COMMUNITY BOARD FEEDBACK PACKAGE

DINING OUT NYC

Business Name: 10TH AVENUE COOKSHOP

Cafe Location: 156 10 AVENUE, NEW YORK, NY, 10011

SECTION 1: Site Plan

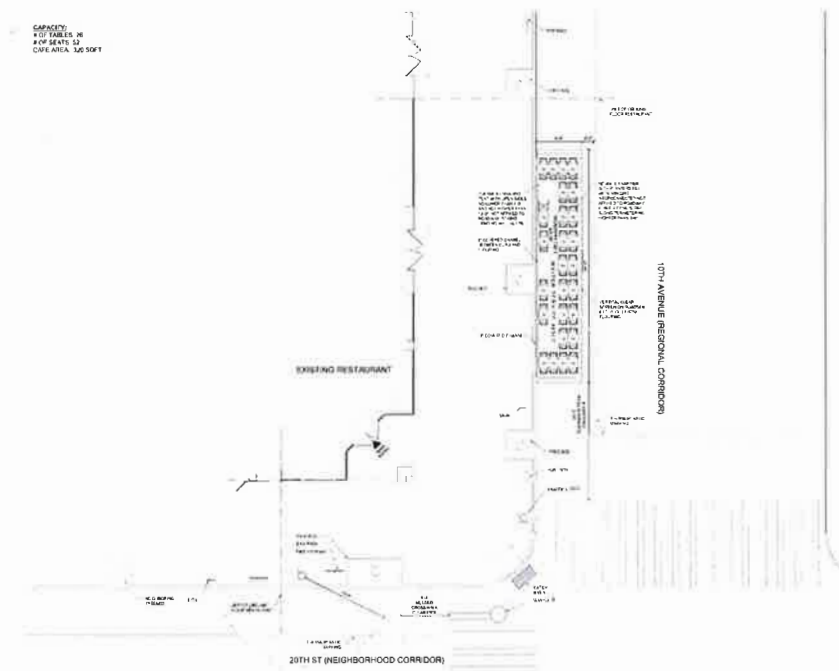
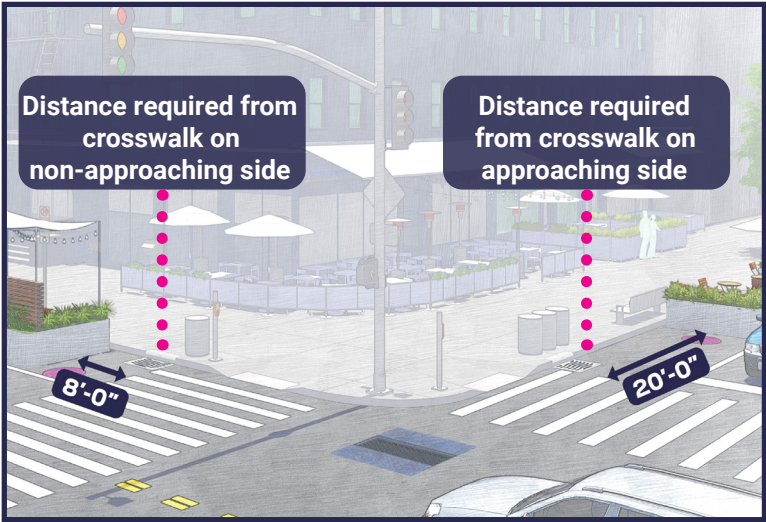
Comments related to the cafe's **physical footprint and dimensions**:
The number of tables and chairs on the proposed Site Plan (26 tables with 2 chairs each) cannot fit in the proposed footprint of the roadway cafe. Applicant has agreed to remove 6 tables with 2 chairs each from the side of the cafe nearest the curb, reducing the cafe to 18 tables 36 seats + 2 ADA seating.

Overall recommendation for the cafe setup:
To fit within the proposed footprint of the roadway cafe, MCB4 requests modifications to the cafe. Applicant has agreed to these modifications and has removed 6 tables with 2 chairs each. A Revised Site Plan, reducing the cafe to 18 tables 36 seats + 2 ADA seatings -- to which applicant has agreed -- is attached.

To fit within the proposed footprint of the roadway cafe, MCB4 requests modifications to the cafe. Applicant has agreed to these modifications and has removed 6 tables with 2 chairs each. A Revised Site Plan, reducing the cafe to 18 tables 36 seats + 2 ADA seatings -- to which applicant has agreed -- is attached.
